SR 37 Transportation and Sea Level Rise Corridor Improvement Plan

February 2018

Appendix D – Response to Comments

DRAFT CORRIDOR PLAN COMMENTS

Exhibit 16: Schematics of representative Intersection operation improvements and lane merge improvements

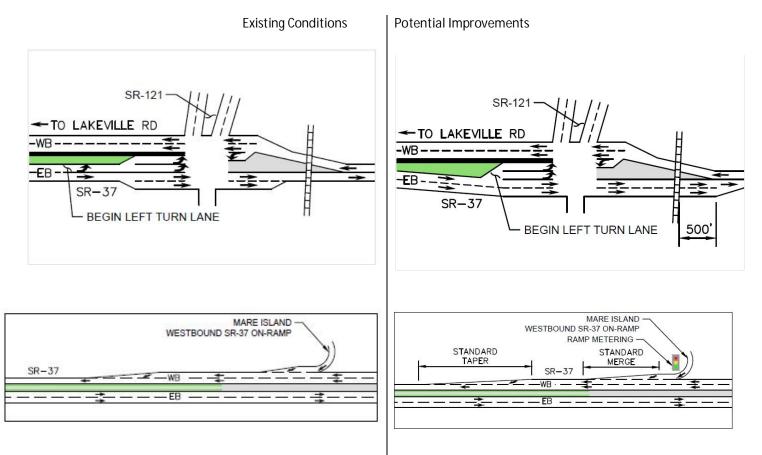
99 DAA Public Comment	Sonoma County Regional Parks	The "Potential Improvements" on Exhibit 16 (page 1 7) shows a proposal to increase the length of the eastbound right lane. The increased lane length would require widening of SR3 7 and could reduce the amount of land available to develop a proposed trailhead parking lot for the Bay Trail. Regional Parks is evaluating a trailhead parking lot at the southwest intersection of SR37 and railroad tracks.	Comment noted.
100 DAA Public Comment	Sonoma County Regional Parks	Many of the concepts (pages 25-26) indicate use of a Class IV bikeway along the reconstructed SR37. Class IV bikeway is intended for the exclusive use by bicyclists and no pedestrians. These options would require construction of a separate exclusive facility for pedestrian use that is not currently indicated. Some of the options being considered in the Bay Trail - Sears Point Connector Feasibility Study, such as an elevated boardwalk or floating boardwalk crossing of Tolay Lagoon may be compatible with SR37 vehicle options and would provide a separate pedestrian and bicycle facility. We recommend at a minimum a Class I bicycle path with a physical barrier separating vehicle traffic on the south side of the roadway facing San Pablo Bay. This will allow trail users to enjoy and experience the views of San Pablo Bay and beyond.	The alternative included in the document are preliminary and include possible options for accomn other alternatives that may be explored during later project development phases.
